**SUBURBAN RAIL LOOP EAST:
ENVIRONMENT EFFECTS STATEMENT
AND
PLANNING SCHEME AMENDMENT GC197**

**SUBMISSION ON BEHALF OF
WHITEHORSE CITY COUNCIL
16 DECEMBER 2021**

**Suburban Rail Loop East EES and Planning Scheme Amendment GC197
Whitehorse City Council – Submission**

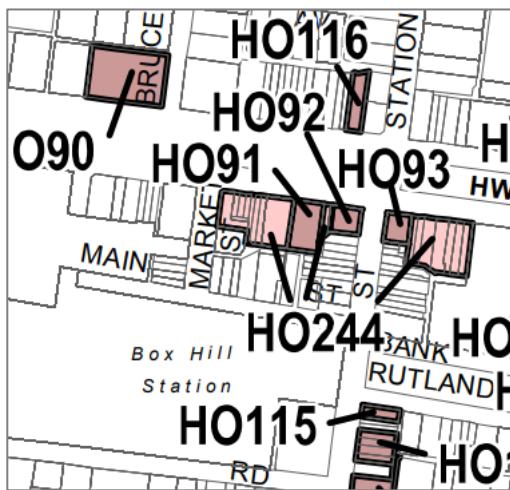
Additional measures should be undertaken to ensure the Project results in an acceptable landscape and visual outcome for the Burwood Station, including but not limited to:

- the underground station concourse level should be extended under Burwood Highway and allow for a new station entrance on the north side of Burwood Highway. This would remove the visual impacts of the overpass and potentially protect many of the trees along the frontage of Bennettswood Reserve;

Figure DSC12.5 Box Hill construction site layout

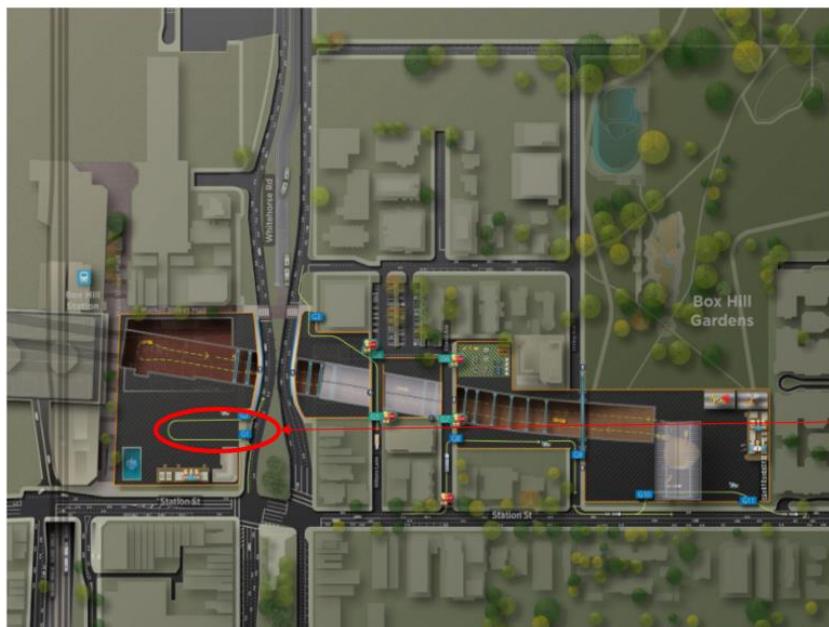
In the case of Box Hill Station, the greatest heritage benefit would be obtained by realignment of the proposed construction route so that it is accessed off Station Street rather than Whitehorse Road. Such a redesign would enable the retention of at least the front part of the former Colonial Gas Association Building, 942-946 Whitehorse Road, Box Hill (an individual heritage place [HO91])

and the single-storey Moderne-style contributory-graded building at 948 Whitehorse Road, Box Hill (within HO244 – Box Hill Commercial Precinct).

The value of such a redesign of the construction site and access arrangements is noted in Technical Appendix L.2 which reads:

In preference [to demolition] and if feasible, the opportunity for further retention should be explored. The priority for additional retention would be the former Colonial Gas Association Building (HO91) (front section or wing, Figure 7.15) as this would substantially reduce the level of the impact on HO244.

Council submits that the station and tunnel plans should be amended to show the retention of the heritage buildings identified above and appropriate changes should be made to the Urban Design Strategy and the EPRs to ensure that outcome is achieved.

Figure 9-58 LVIA

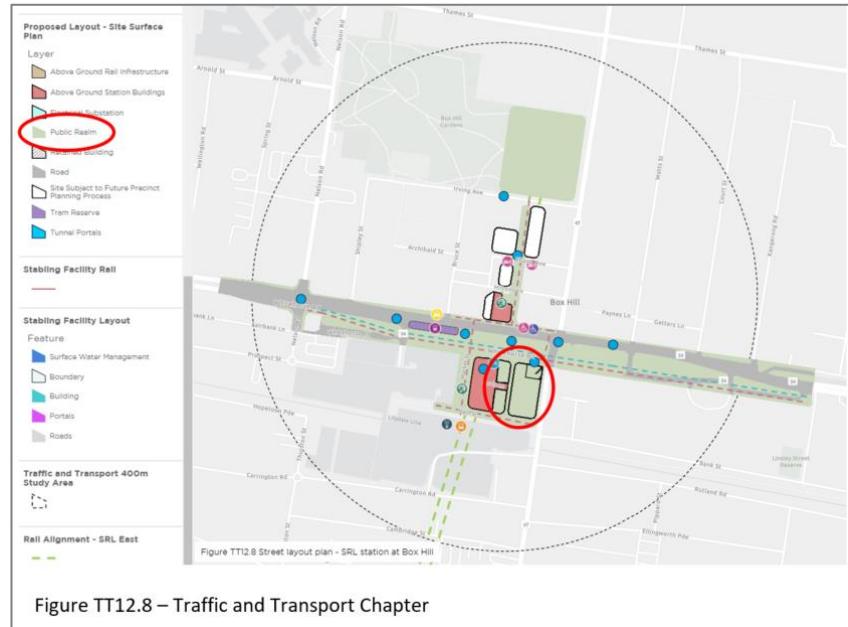
contends that the land must be returned as public realm, particularly to cater for the replanting of Project vegetation.

Examples of figures in EES documentation showing land to be 'public realm':

Figure 9-45 LVIA

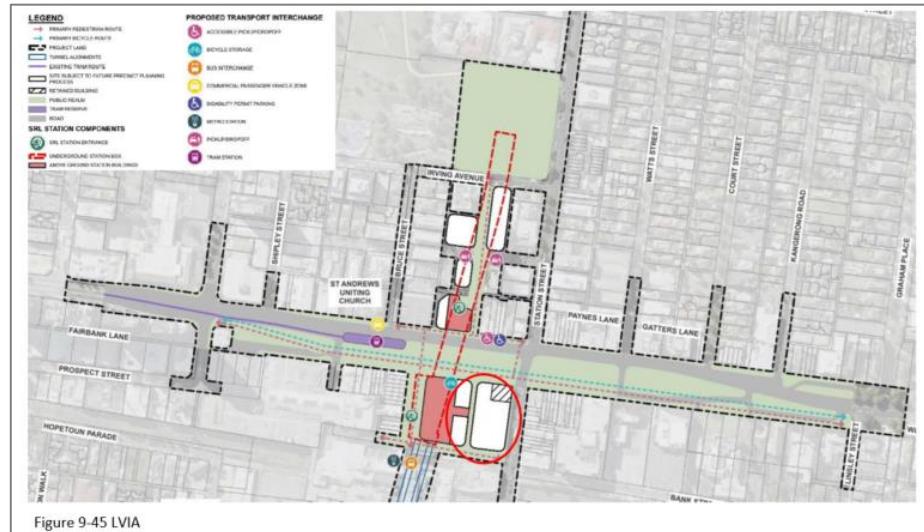
Example of figures in the EES documentation showing land marked for 'future development':
